# Access Compliance Report

## Public Rights-of-Way

Intersection ID: 46822	Main Street: RED_BIRCH_DR	Cross Street: SCOTCH_PINE_CR	Location: NW
ADA ID: 7A0160824265	Ramp Type: PerpDiag	Initial Pass/Fail: Fail	Overall Compliance: No
		Severity Score: 8.75

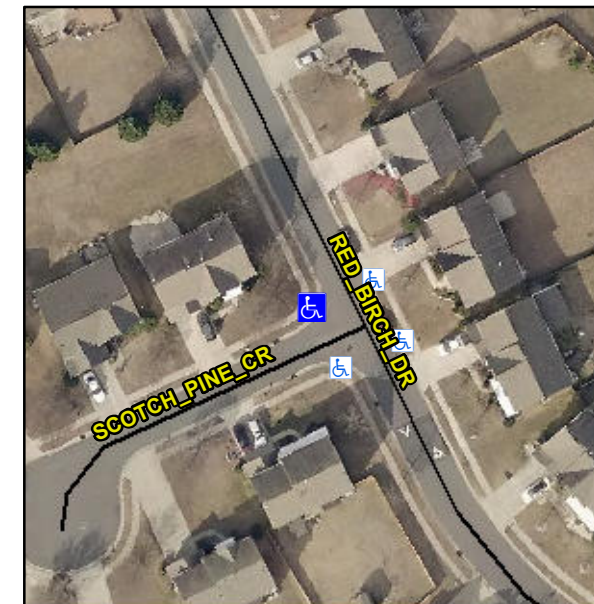
**Not Found, R304.5.1**

Compliance	Description	Data	Compliance	Description	Data
N/A	Ramp Length (in)	49.0	Yes	Ramp Slope (%)	5.8
No	Ramp Width (in)	38.0	Yes	Ramp XSlope (%)	0.7
N/A	Flare Type LT	N/A	N/A	Flare Type RT	N/A
N/A	Flare Slope LT (%)	N/A	N/A	Flare Slope RT (%)	N/A
N/A	Flare Traversable LT?	N/A	N/A	Flare Traversable RT?	N/A
N/A	Landing Length (in)	N/A	N/A	DWS Provided?	N/A
N/A	Landing Width (in)	N/A	N/A	DWS Contrast?	N/A
N/A	Landing Slope (%)	N/A	N/A	DWS Length (in)	N/A
N/A	Landing X Slope (%)	N/A	N/A	DWS Full Width?	N/A
N/A	Landing Curb? (Y/N)	N/A	N/A	DWS Offset (in)	N/A
N/A	Shared Landing?	N/A			
N/A	Gutter Ponding?	N/A	N/A	Gutter Slope (%)	N/A
N/A	Gutter Lip Ht (in)	N/A	N/A	Gutter X Slope (%)	N/A
N/A	Painted X Walk1?	No	N/A	Painted X Walk2?	No
	X Walk 1 Direction	To S		X Walk 2 Direction	To E
N/A	X Walk 1 Width (in)	N/A	N/A	X Walk 2 Width (in)	N/A
	X Walk 1 Slope (%)	1.3		X Walk 2 Slope (%)	0.0
	X Walk 1 X Slope (%)	1.1		X Walk 2 X Slope (%)	3.7

**Remove & Replace Curb Ramp With Two New Directional Ramps or Equivalent.**
